To consider the following:

A request by Ken Beck, Thistle Dew Ranch for a Variance in accordance with Village of Volente Code of Ordinances 2009-O-103, Section 9.05.115, (Cut & Fill) to exceed 5' maximum allowed at the location (15502 Mary Street) Lot 1, Thistle Dew Ranch Subdivision, sur 10.23 acres.

A request By Ken Beck, Thistle Dew Ranch for a Variance in accordance with Village of Volente Code of Ordinances 2004-O-36, Section 33.340 (Slope Limits) no construction or land disturbing activities shall be permitted on natural grades with slopes 25% or steeper at the location (15502 Mary Street) Lot 1, Thistle Dew Ranch Subdivision, sur 10.23 acres.

**Re: Site Plan Review
15502 Mary Street**

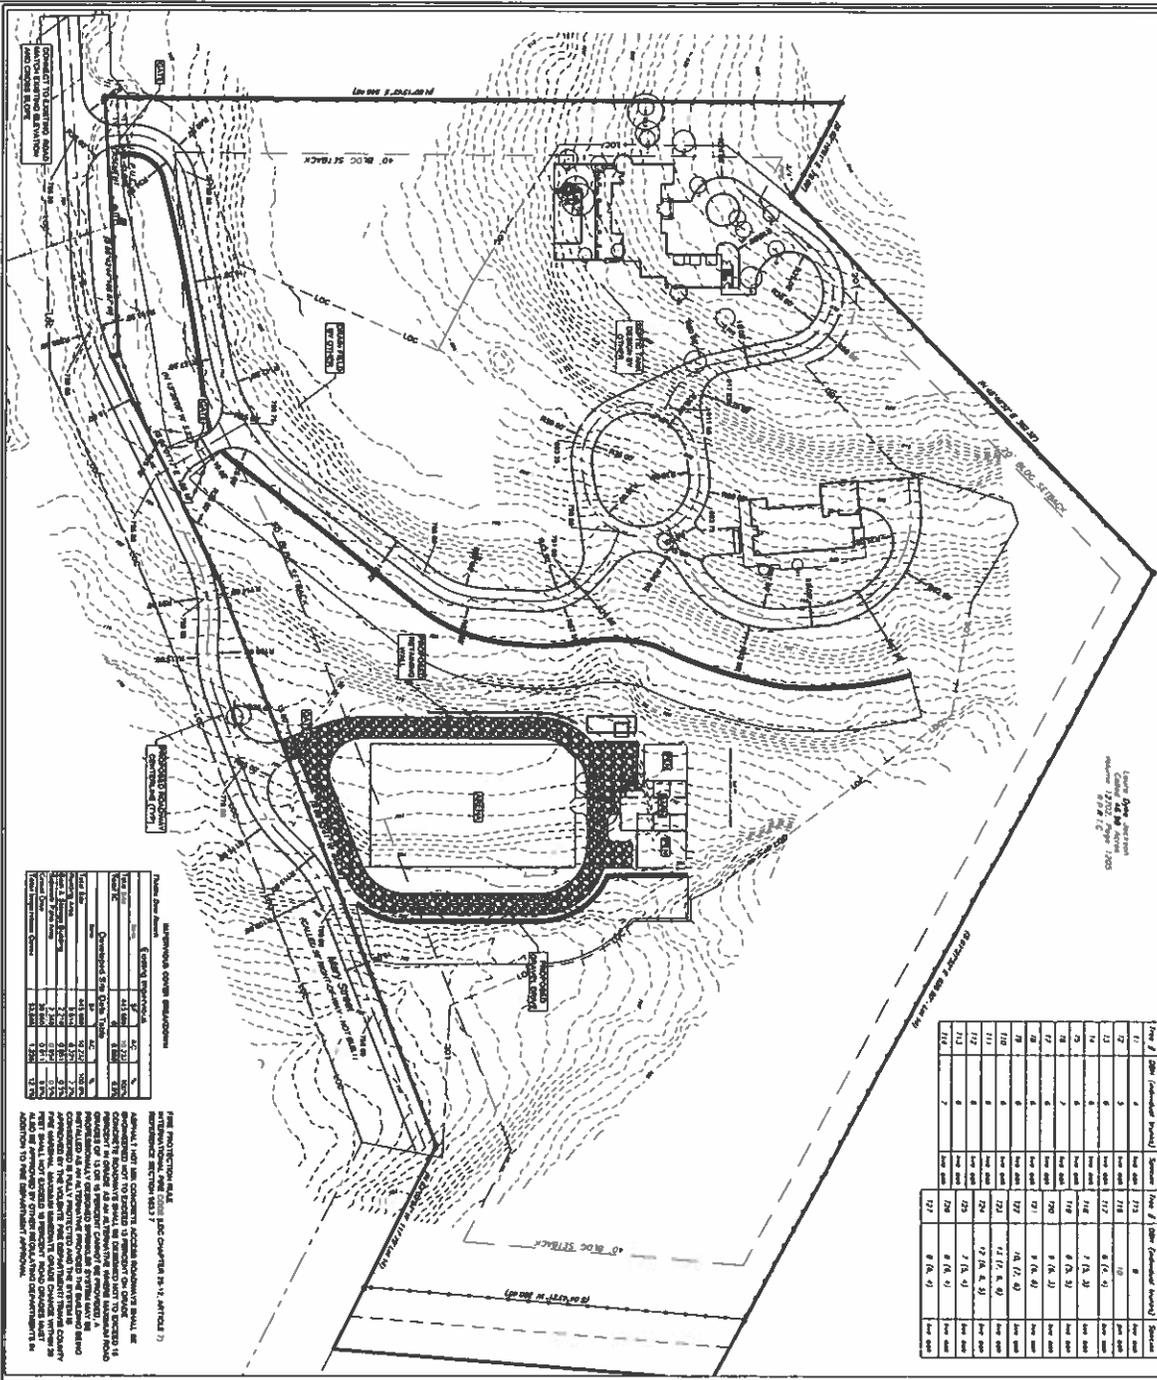
- Please provide a cross-section of the proposed drive located in the ROW.
- Please establish grades for the retaining walls shown on the grading plan. Note: A wall greater than 4-feet from the footing must be designed by a structural engineer. Also, cut and fill greater than 5-feet requires a variance.

- Please show how the grading for the driveway will tie to existing grades, please note: erosion control matting shall be installed on all disturbed areas with a finished grade of four to one (4:1) or steeper.

- The water quality plan states a 3-foot wide and 8-foot deep infiltration stone level spreader. Please provide grading along the level spreader to more clearly define the intent of the design or add another detail to the plan. Walls greater than 4-feet will need to be designed by a structural engineer.

- The P2 drainage area time of concentration (TOC) line makes two 90 degree turns, however the grading plan doesn't reflect any grading changes, please update the TOC and drainage calcs to reflect an accurate flow pattern and flowrate.

- Please add a rock berm at the concentrated flow through the site. It appears approximately 30 acres flow through and adjacent to the arena area. Add the following E&S Details: tree protection, rock berm and stabilized construction entrance to the plans.
- Please define the driveway material and type as dip style or if culverts are proposed from the Mary Street ROW. Add the driveway detail to the plans.
- Please show the location of the mailbox.
